Chapel Lane, Widnes: Response to Halton BC and Knowsley Council

Ref: VE/ITM19092-002A
Date: 1 May 2025

- 1.1 This Technical Note responds to highways comments received from Halton Borough Council (HBC) and Knowsley Council (KC) in relation to Taylor Wimpey's development proposals at Chapel Lane, Widnes (Outline Application Ref: 23/00244/OUT (HBC); 23/01037/OUT (KC)). The Council's comments were set out in correspondence dated 13th March 2025.
- 1.2 Given the degree of overlap between the two sets of comments, this note seeks to respond to the issues raised in both authorities' responses. This note considers issues relating to the following aspects of the proposals – each is considered in turn below:
- Off-Site Active Travel Package
 - Proposed Access onto Chapel Lane – Primary Access and Emergency Vehicle Access
 - Internal Site Layout
 - Other Issues

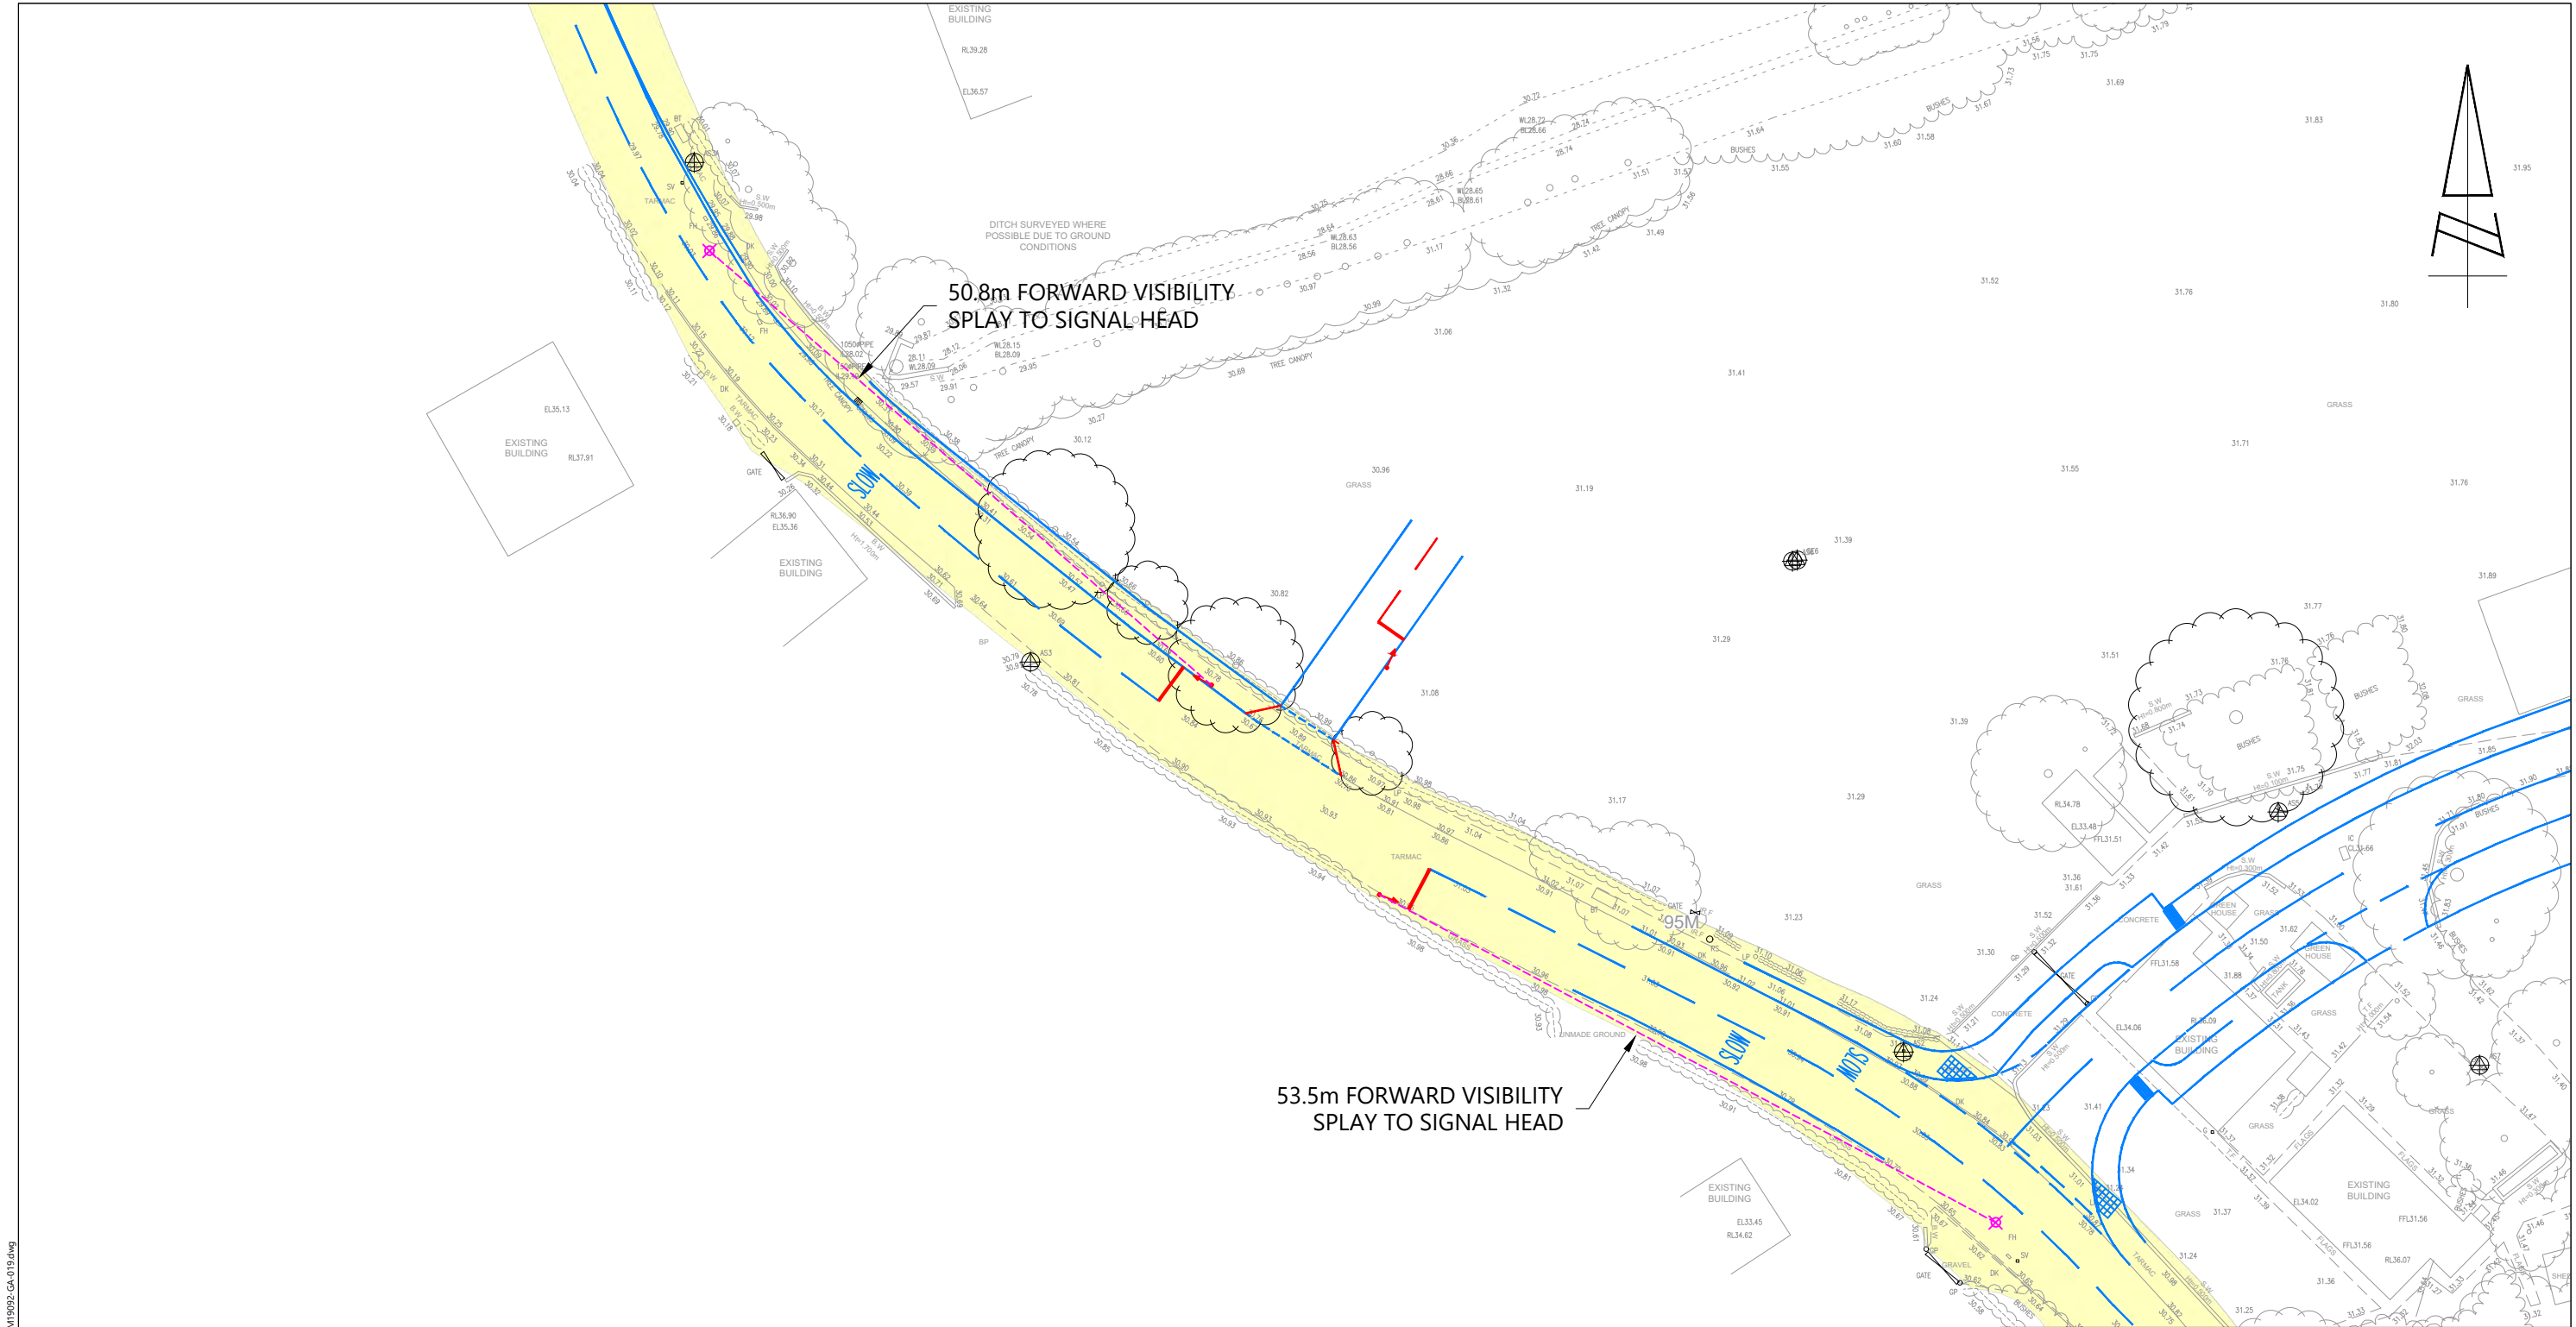
3.7.2 HBC has noted that that they assume that three-way traffic management would be required on Chapel Lane to control the use of the EVA in the event of an emergency. In almost all instances, the EVA would only need to be used by emergency vehicles and therefore it is not considered that any form of temporary traffic management / signal control would be necessary.

3.7.4 However, in the unlikely event that an emergency arose which required the EVA to be used by general traffic for a limited period of time, it is likely that some form of traffic management would be needed. Drawing ITM19092-GA-019 enclosed at **Appendix I** shows how signal-controlled traffic management could be installed at the access and demonstrates that the required forward visibility to the proposed temporary signal heads would be acceptable. Tapers have been added to either side of the access to enable a fire tender to enter the site whilst vehicles are queuing at the signals within the site.
